# Addendum No. 2

June 6th, 2016

Project: Gallatin Valley YMCA

- 1. Sheet E001
  - a. LIGHTING FIXTURE SCHEDULE- Add type R3, 6" RECESSED LED CAN LIGHT, 1400L, SHOWER TRIM, LITON LHALD625C071UE / LRLD642C-WL.

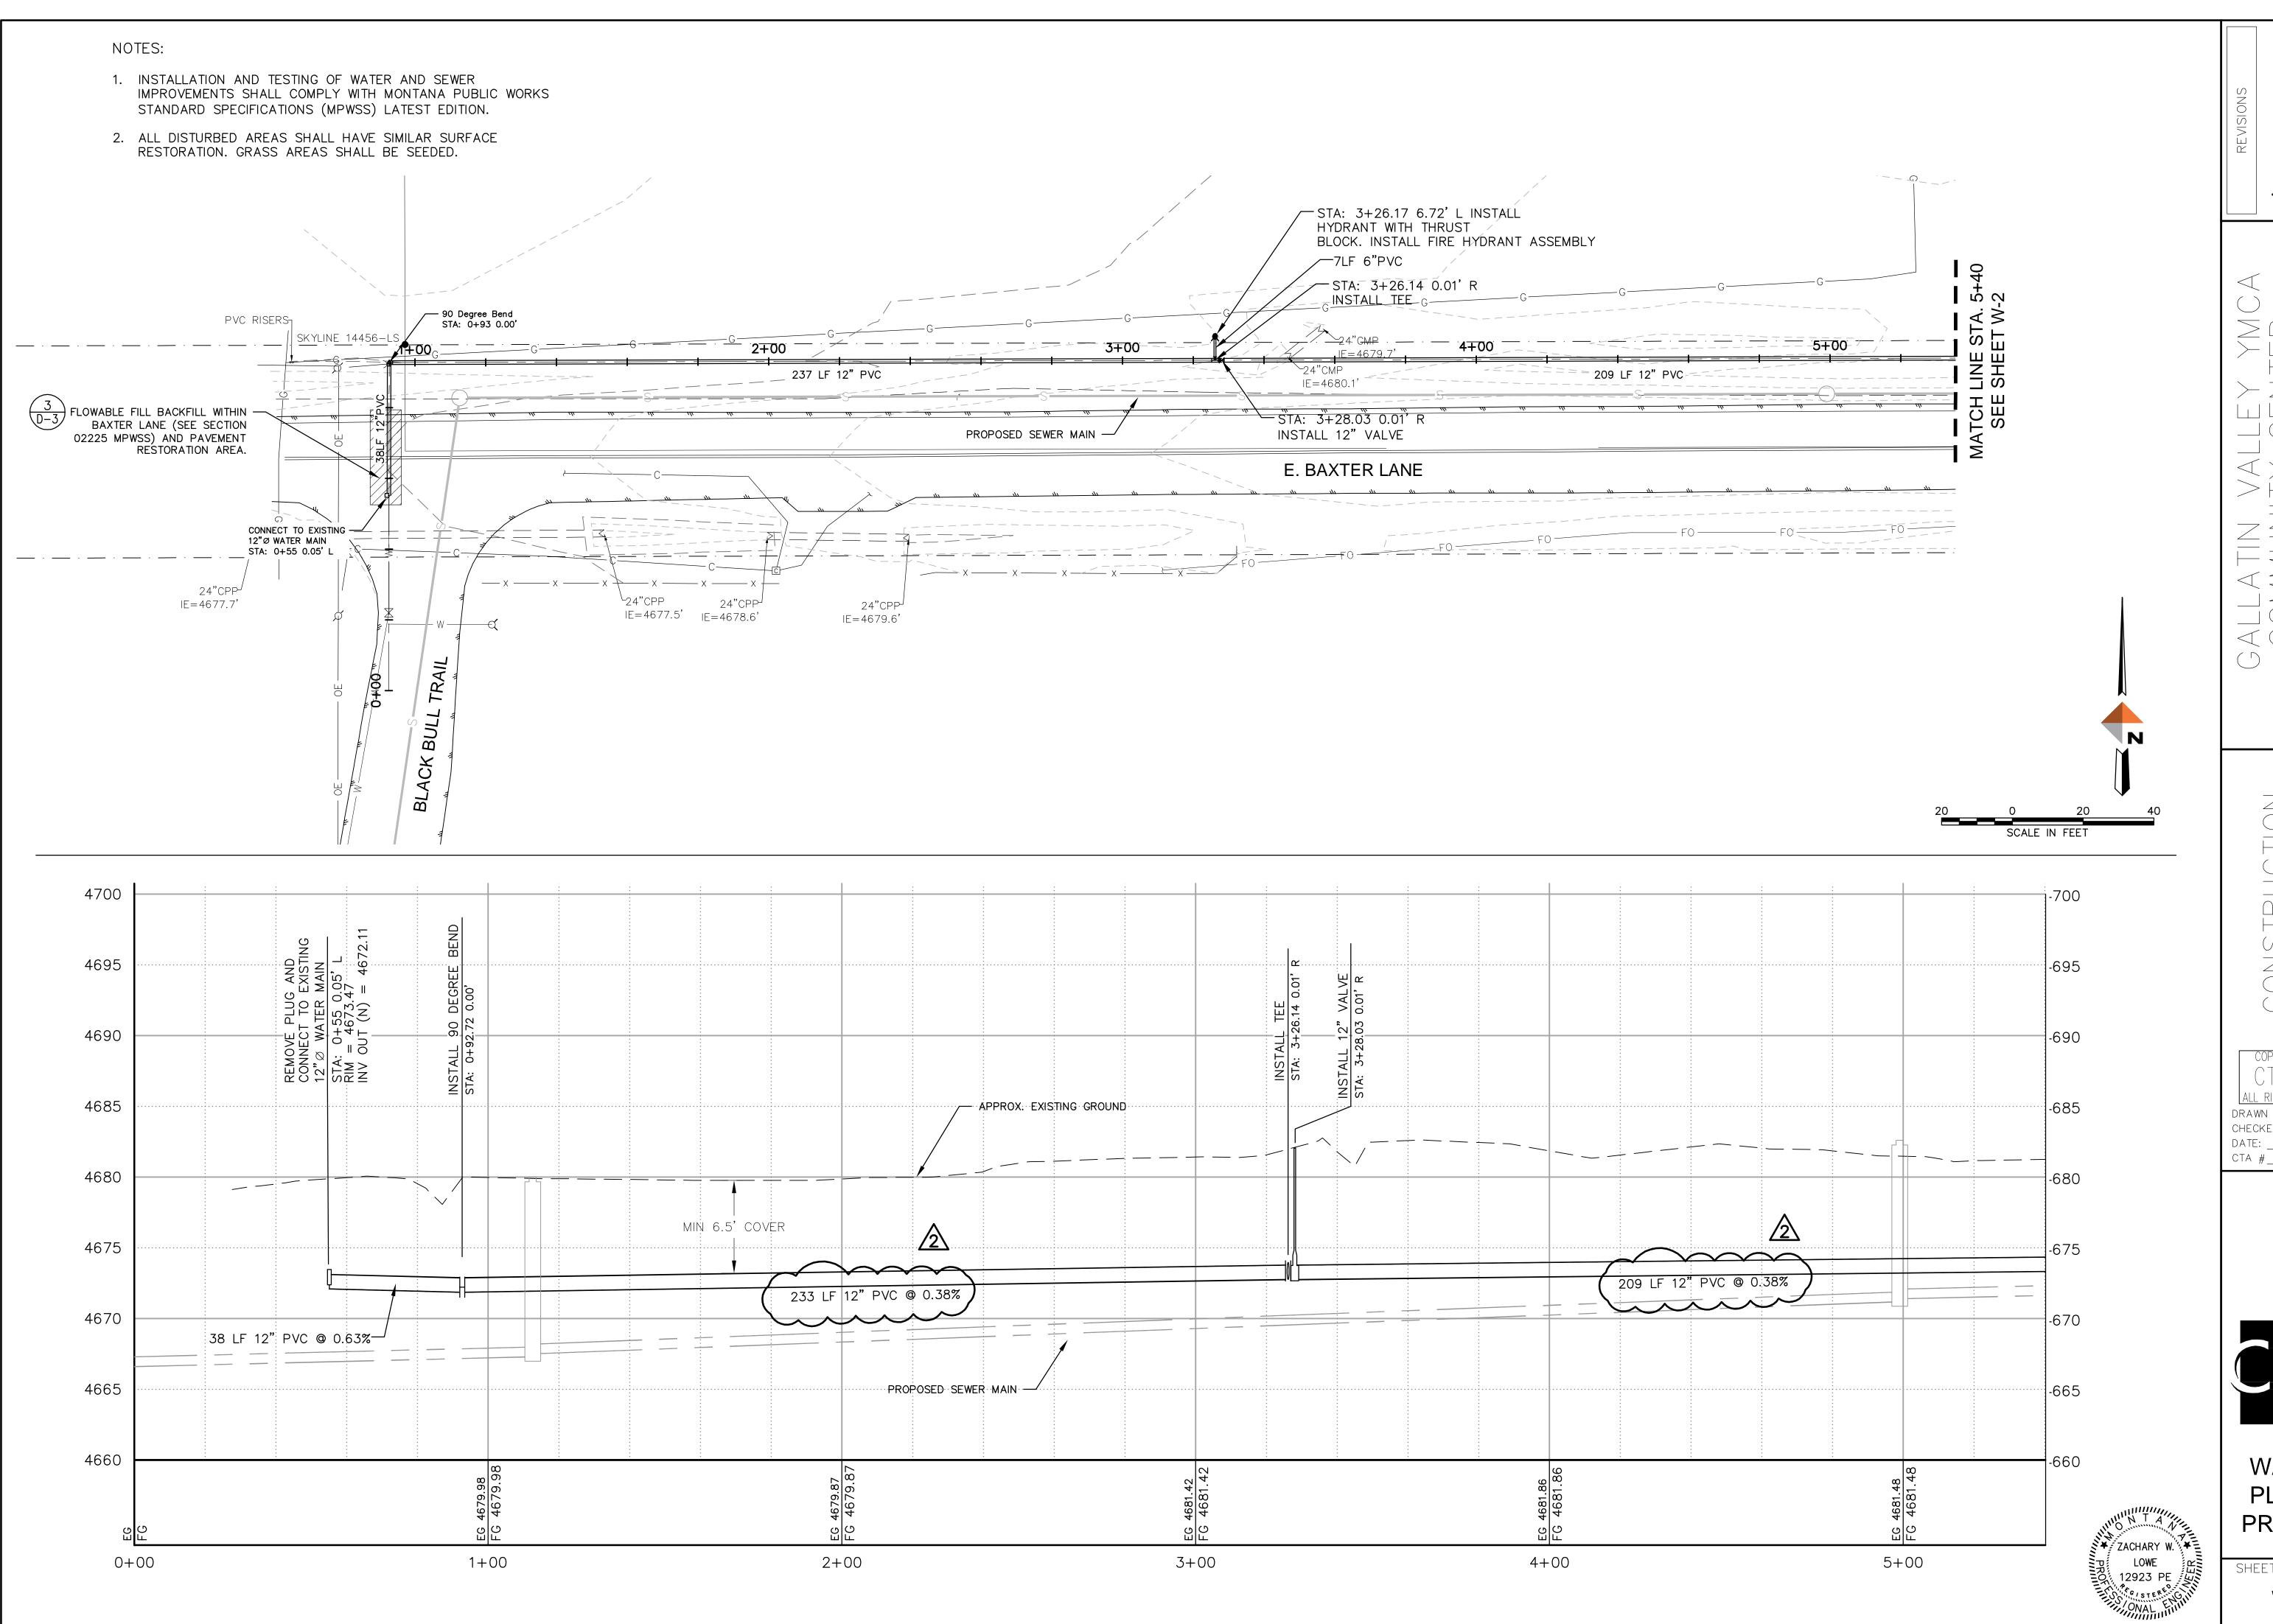
LIGHTING FIXTURE SCHEDULE- Add type R3E, 6" RECESSED LED CAN LIGHT, 1400L, SHOWER TRIM W/EMERGENCY, LITON LHALD625C071UE / LRLD642C-WLEM2.
